City of Orting Planning Commission

**Special Meeting
October 18, 2021
7 pm Virtual Meeting**

City of Orting
ADR 2021-09 Duplex

City of Orting
ADR 2021-10 Retail/Residential Structure

FRONT ELEVATION "A"
SCALE: 1/4"=1'-0"

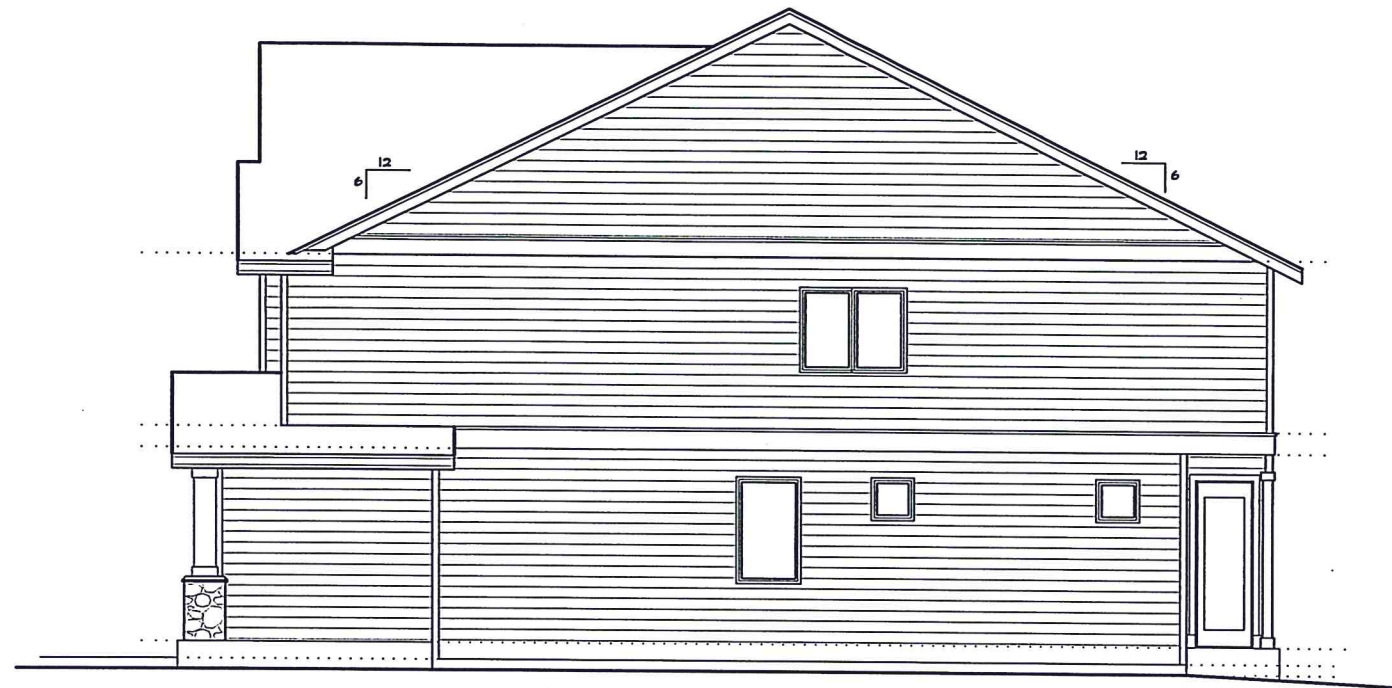
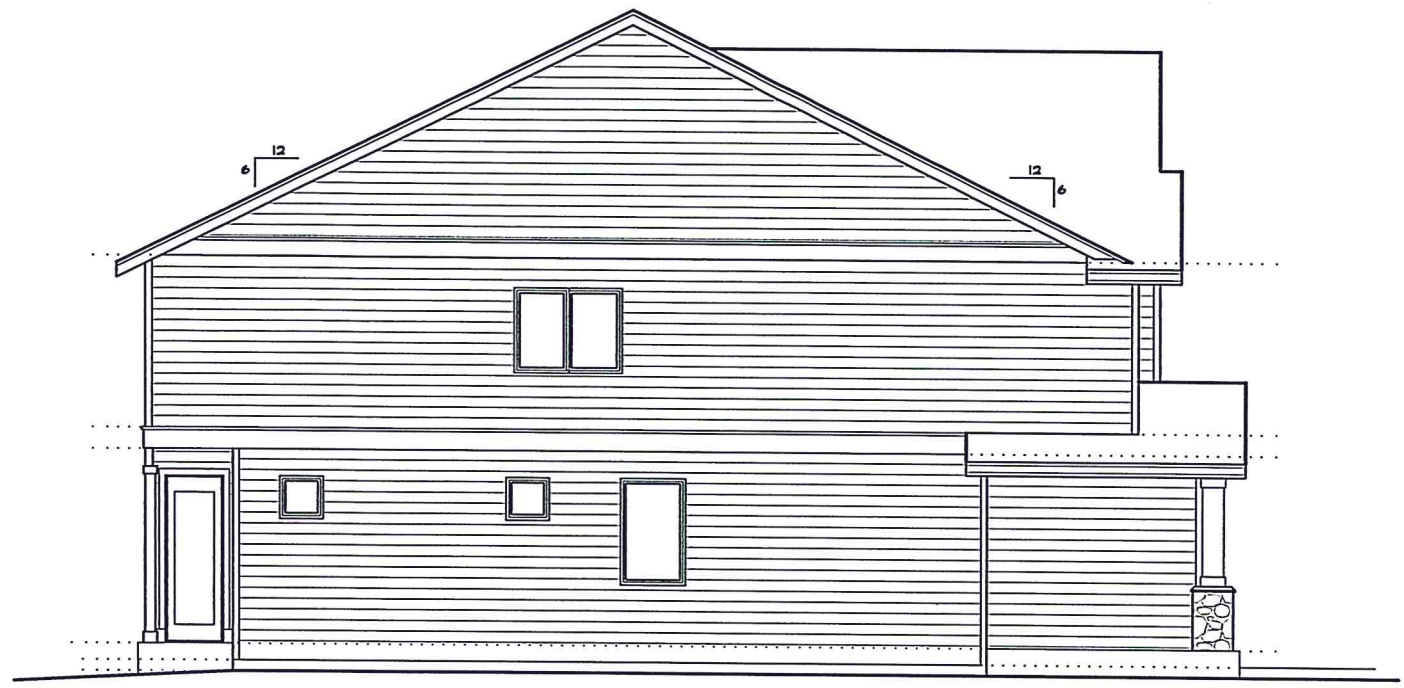
- The applicant has submitted a picture of a goose-neck light. The duplex design does not indicate the location(s) of the lighting on the structure.
- The applicant has chosen four (4) Sherman Williams Historical Colors for the exterior of the structure. Colors confirmed on Sherman Williams web-site. Applicant did not include a color rendering of the duplex.

- Applicants duplex design includes several architectural aspects to meet the City’s architectural design guidelines; gridded windows, batt & board and other western architectural attributes.

STAFF RECOMMENDATION: Staff recommends approval of the duplex’s architectural design, with clarification on the address.
